**Memorandum  
Planning & Development Services Division**

**RE:** **P.Z. 11-2014 THF Chesterfield Development LLC (The Commons)**: A request for an ordinance amendment to Ordinance 2081 to modify development criteria and use restrictions for a 160.195 acre tract of land zoned "C-8" Planned Commercial District located between US Highway 40/Interstate 64 and Edison Avenue and East of RHL Drive (17T140253, 17U340067, 17U330112, 17T130166, 17T110212, 17T140143, 17U320102, 17U340089, 17U340100, 17U340111, 17U340144, 17T140341, 17T130144, 17U340155, 17U330091, 17T130089, 17T140165, 17T130155, 17U340090, 17T130133, 17U330123, 17U330101, 17T140132, 17T130210, 17T140187, 17U340078, 17T130188, 17T140088, 17T140330, 17U330255, 17U330321, 17T120741, 17U330288, 17T140101).

## Greensheet Amendments

**EXHIBIT "A"**

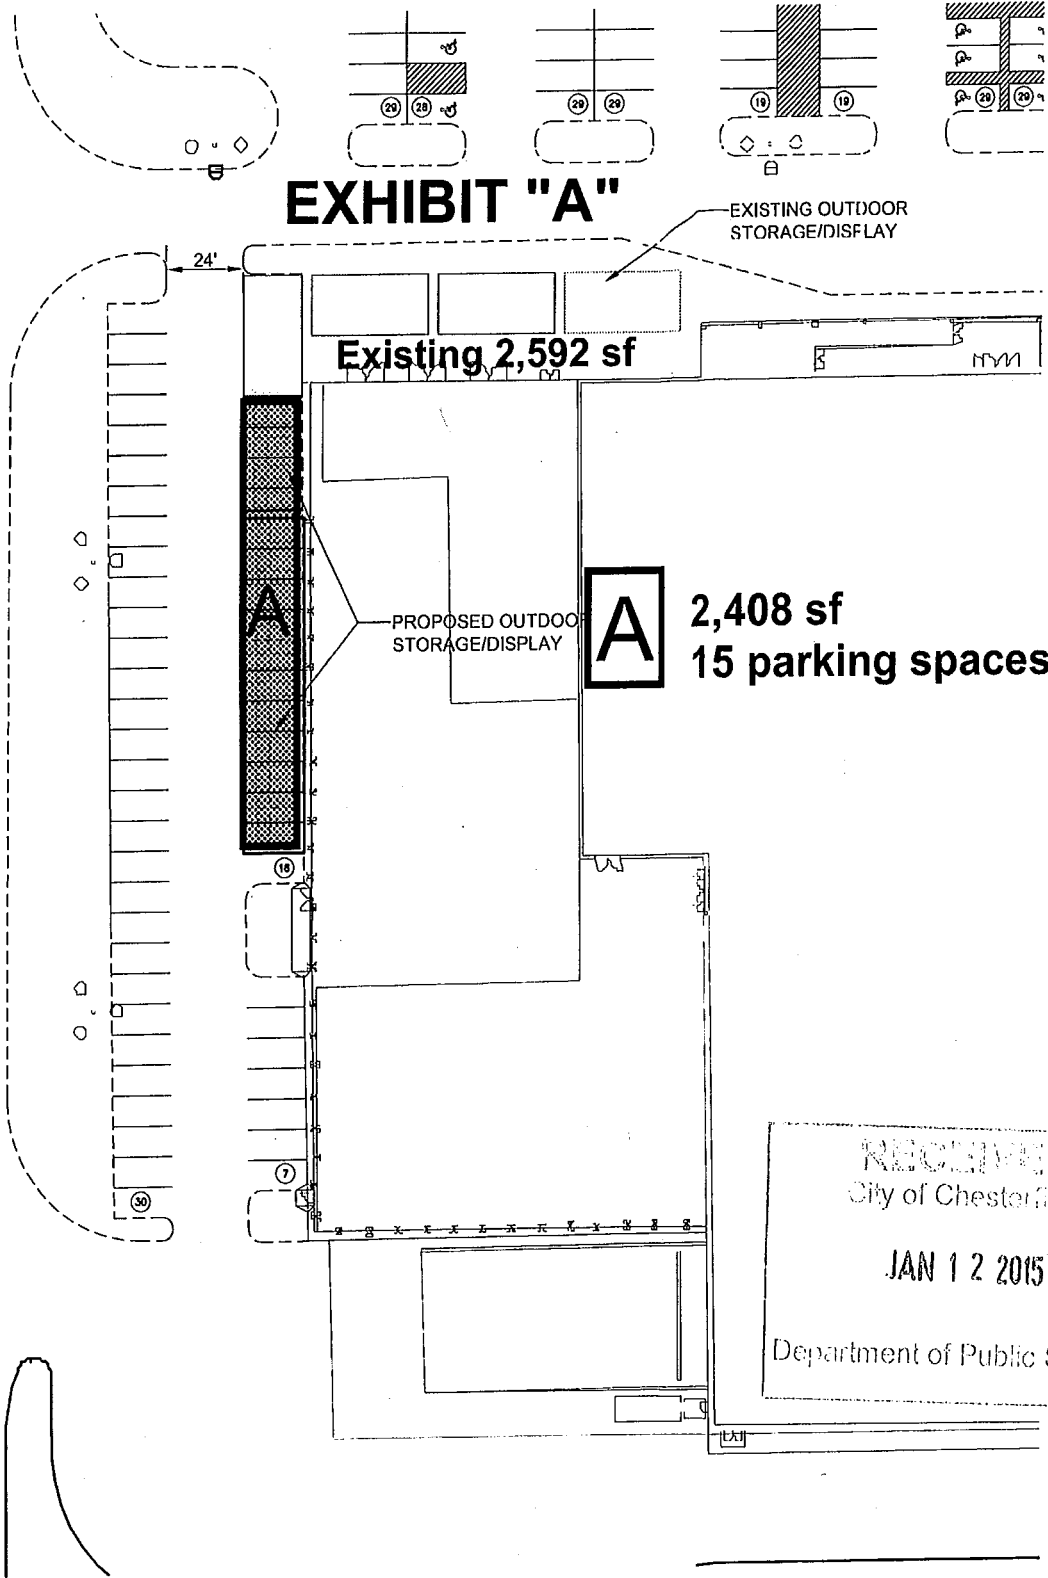
- a. The area to be utilized for outdoor storage shall be limited to 5,000 sq. ft. as delineated on the attached Exhibit A and is permitted ~~year-round~~ for the period of March 15<sup>th</sup> until October 15<sup>th</sup> of each year.

- b. ~~Materials in the storage area shall not be stored in shipping containers or on pallet racks.~~ Materials allowed in all outdoor storage areas shown on Exhibit A shall be limited to plants, soil, mulch, and other related landscape materials and shall not be stored in shipping containers or on pallet racks.

- f. During times of outdoor storage in areas along the western side of the existing garden center as depicted in Exhibit A, traffic along the internal drive parallel to RHL Boulevard shall be restricted to one-way traffic traveling north to south with appropriate directional signage

Exhibit "B"

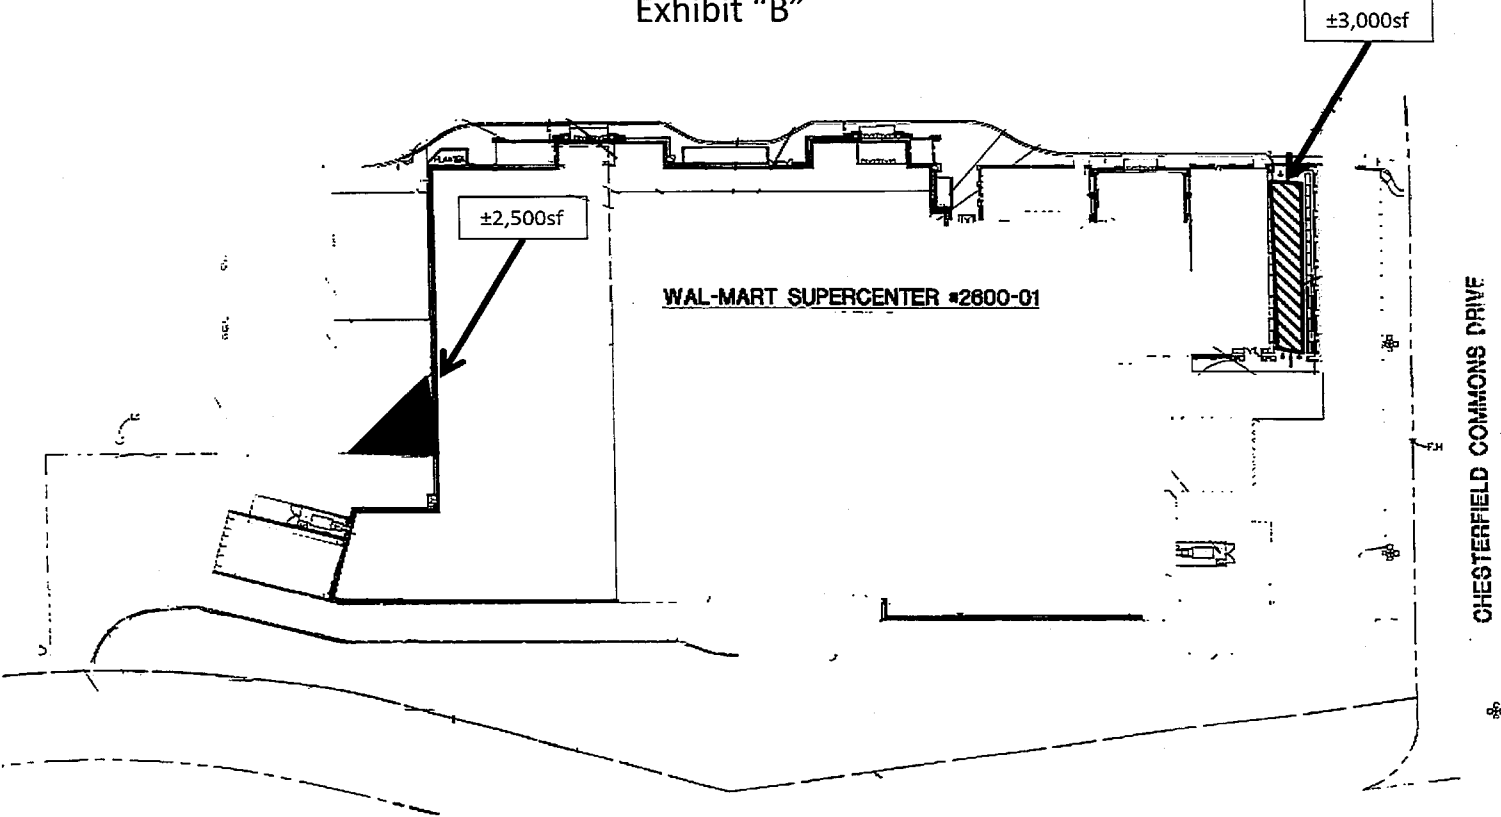
- g. The seasonal outdoor storage area shall be limited to approximately 3,000 sq. ft. as delineated on the attached Exhibit B. Storage in this area shall be restricted to a height of ten (10) feet.
